**AGENDA**  
**BOARD OF PUBLIC WORKS MEETING**  
**Tuesday, September 29, 2020 at 7:00 p.m.**  
**Jackson Village Hall**  
**N168 W20733 Main Street**  
**Jackson, WI 53037**

**SECTION 00941  
CHANGE ORDER**

Change Order No. 2

Date of Issuance:	August 31, 2020	Effective Date:	August 31, 2020
Owner:	Village of Jackson	Owner's Contract No.:	A-20
Contractor:	Wondra Construction, Inc.	Contractor's Project No.:	
Engineer:	Cedar Corporation	Engineer's Project No.:	05789-0008
Project:	Spruce Street and Ridgeway Drive Extensions	Contract Name:

STANDARD CONCRETE DRIVEWAY APPROACH & SIDEWALK

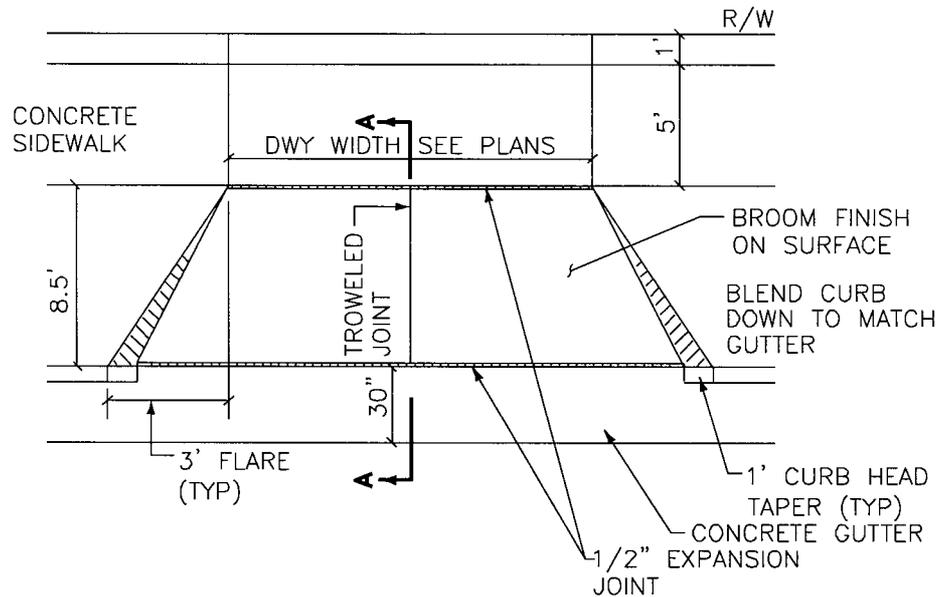
As discussed at yesterday's progress meeting, the Owner has decided to add a driveway approach within the south curb line of Spruce St at Ridgeway Dr. extended. The proposed approach is 25' wide (excluding flares) and includes a 7" concrete approach and sidewalk. Attached please find revised plan sheet 5 of 27 which includes the proposed approach plus, a second sheet which includes a detail for a Standard Concrete Driveway Approach & Sidewalk.

**ADD 360 Square Feet of 7" Concrete Driveway Apron & Sidewalk @ \$ \_\_\_\_\_/SF = \$ \_\_\_\_\_**

I met with the Owner this morning to discuss your submitted unit price of \$7.60 per lineal foot related to the addition of a 7" concrete driveway approach and sidewalk on Spruce Street. As a result, the Owner finds your submitted unit price to be reasonable and therefore, has been approved by the Owner.

VILLAGE OF JACKSON  
SPRUCE STREET AND RIDGEWAY DRIVE EXTENSIONS  
WASHINGTON COUNTY, WISCONSIN  
SPRUCE STREET PLAN AND PROFILE

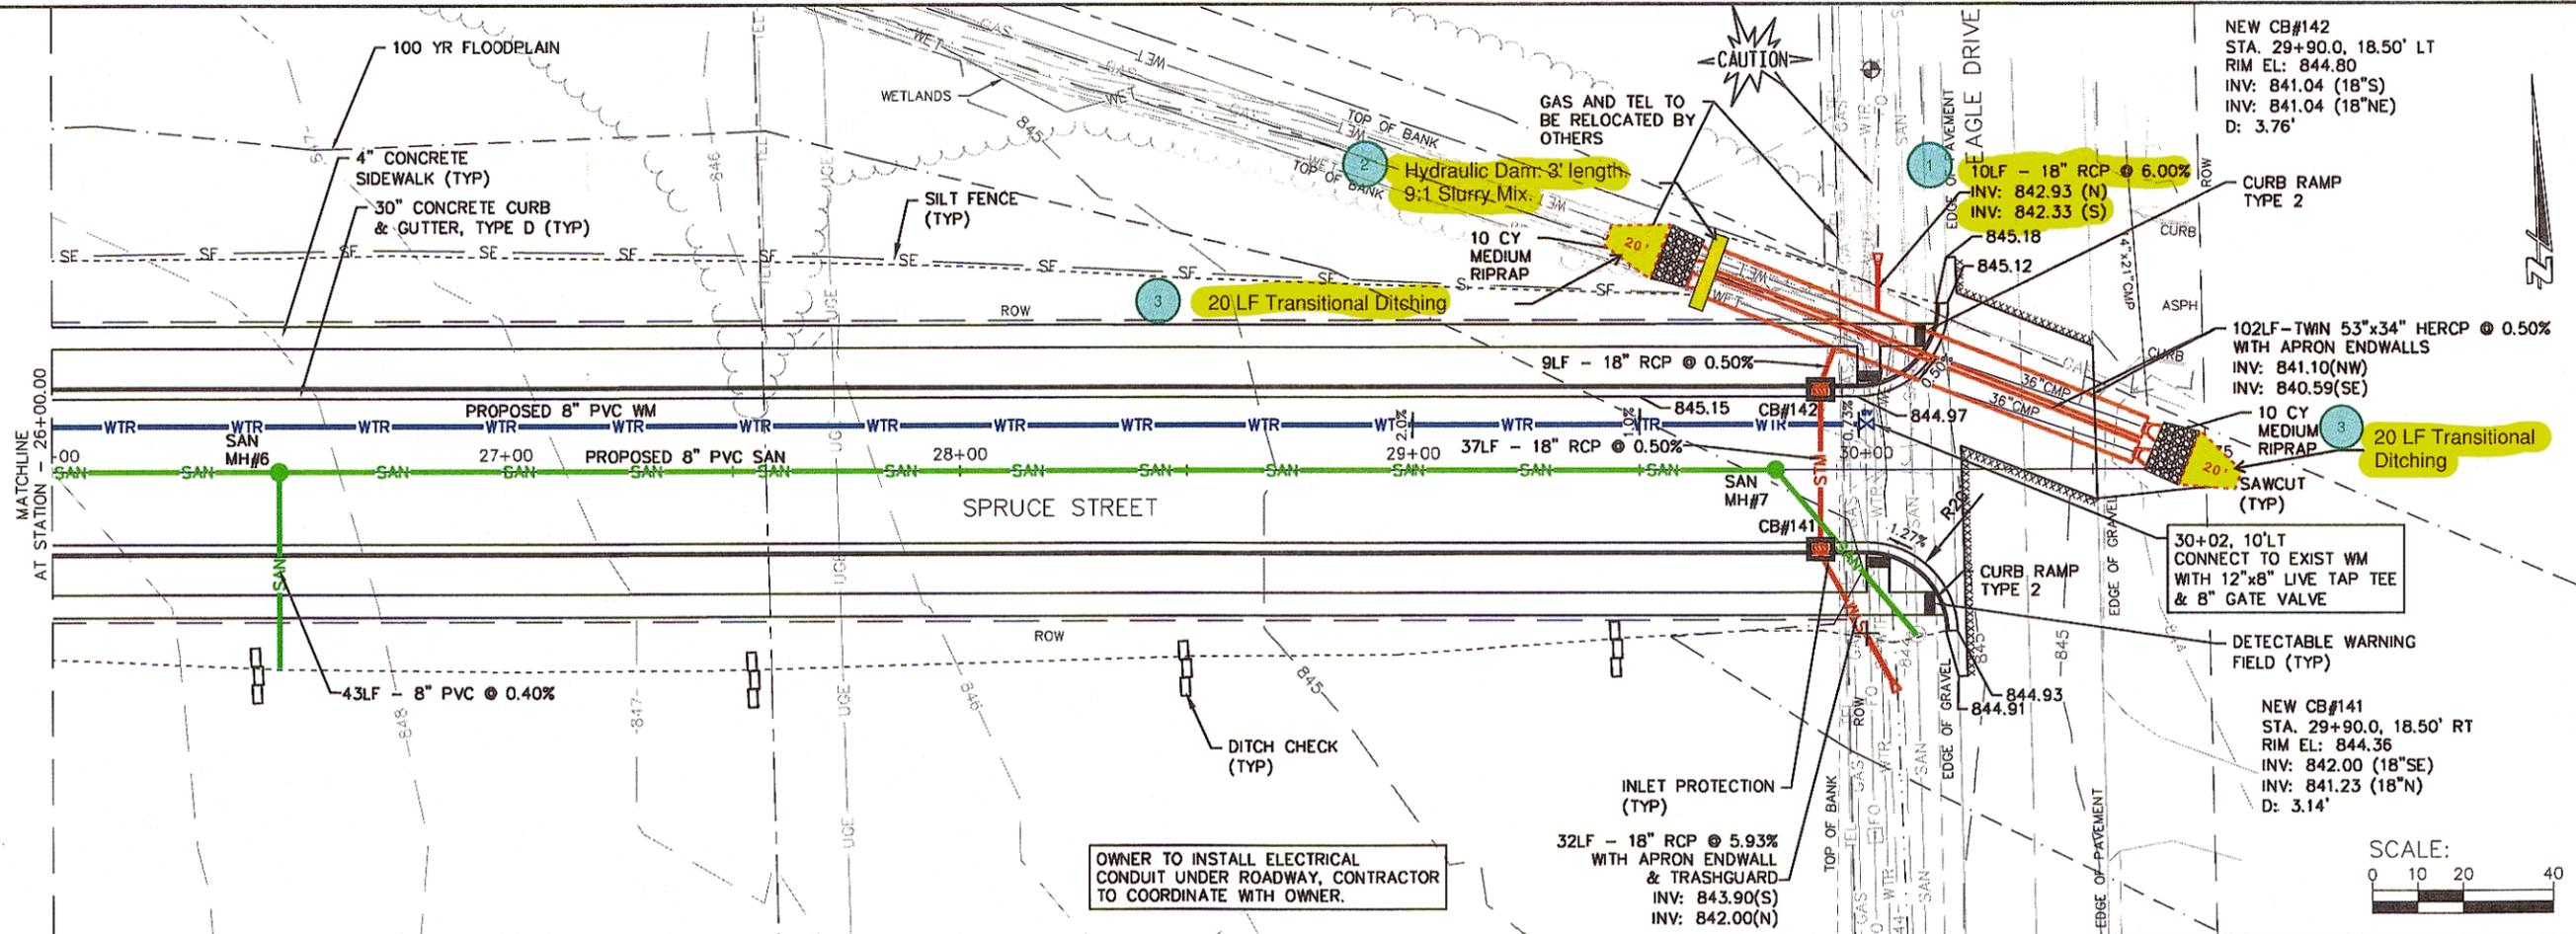
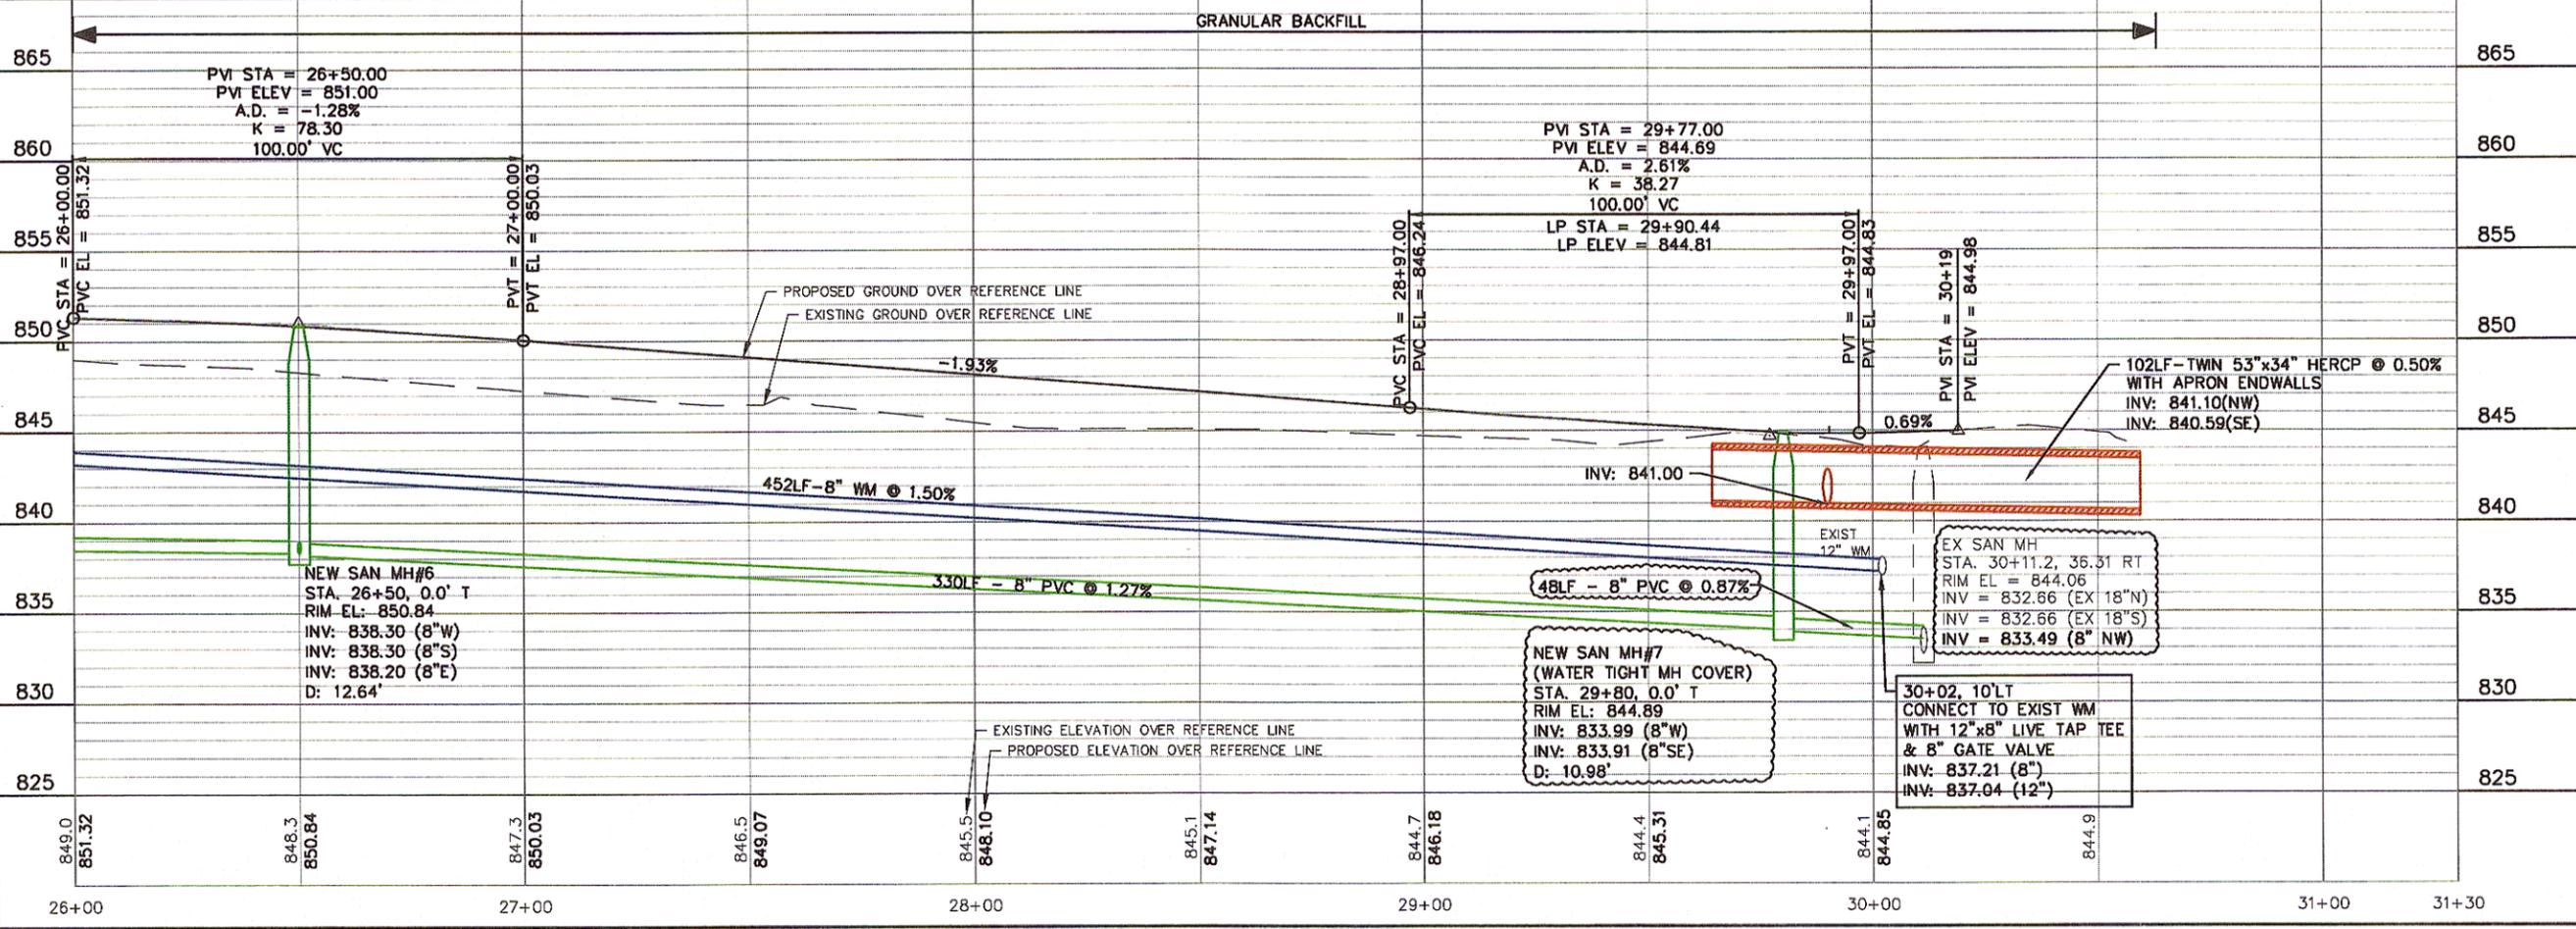
"The Owner of the subject project is requesting price quotes for the following items associated with the Eagle culvert installations as illustrated below and within the attached plan sheet:

Install 18" RCP culvert to accept existing ditch flow on the north side of cross culverts. Work to include 10 LF of 18" RCP, Apron End Wall, Connection to Existing Culvert, Backfill and Lawn Restoration. Provide pricing as follows:

Install 3' hydraulic dam at the east end of culverts using 9:1 Slurry Mix encompassing entire width of trench, pipe bedding up to top of pipe. Provide pricing as follows:

Perform transitional grading from end of rip rap areas transitioning 20' to the contours of existing creek banks and flow line east & west. Work to include: excavation, grading, topsoil, seeding and erosion mat within side slopes. Provide pricing as follows:

- The cost of \$1,100 each appears reasonable under the circumstance that the dam installation required specific effort related to re-excavating and backfilling for the sole purpose of installing the dam.
- In the case of the dam installed around the water main, the dam was installed at the time of the water main connection. Under this condition, the cost of the dam would be primarily reduced to the cost of the dam material: Approx. one cubic yard of slurry mix. **Revised price of \$400 for the dam around the water main.**

Based upon the above information, we ask that you revisit your pricing related to the water main dam and resubmit."
